MEDTRONIC NAVIGATION, INC.

URGENT: VOLUNTARY MEDICAL DEVICE CORRECTION

O-arm™ O2 Imaging System Detector Panel Firmware Update

May 2026

Figure 1. Example of ASIC image artifacts. (a) 2D scan with rectangular artifact (b) 3D Scan with ring artifact

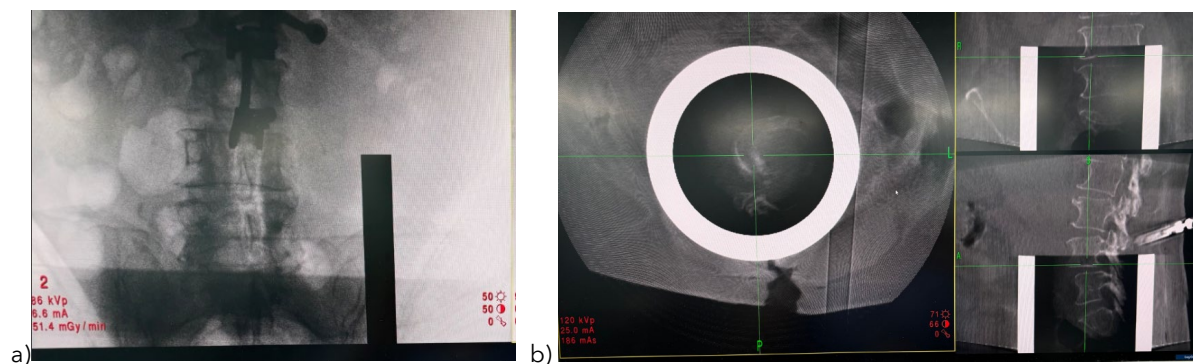
Medtronic has identified the potential for image artifacts caused by an anomaly in the O-arm O2 Imaging System's detector panel firmware.

The issue presents as an artifact in both 2D and 3D images and can be resolved by power cycling (rebooting) the system. If the artifact is present in a 2D image and the user proceeds to a 3D scan without rebooting the system, the artifact will persist in the 3D images as shown in the images in Figure 1 below.

- Please complete and return the Customer Confirmation Form enclosed with this letter, acknowledging that you have received this information. The form may be emailed to neuro.quality@medtronic.com.
- You may continue use of the system prior to service by Medtronic to update the firmware. The issue is intermittent and may not present, however if it does it can be resolved by power cycling (rebooting) the system.
- A Medtronic Field Service Engineer will contact your facility to schedule time to update the firmware on your system to permanently resolve this issue.
- This notice should be passed on to those who need to be aware within your organization or to any organization where the affected devices have been transferred.
- Please maintain a copy of this notice in your records.
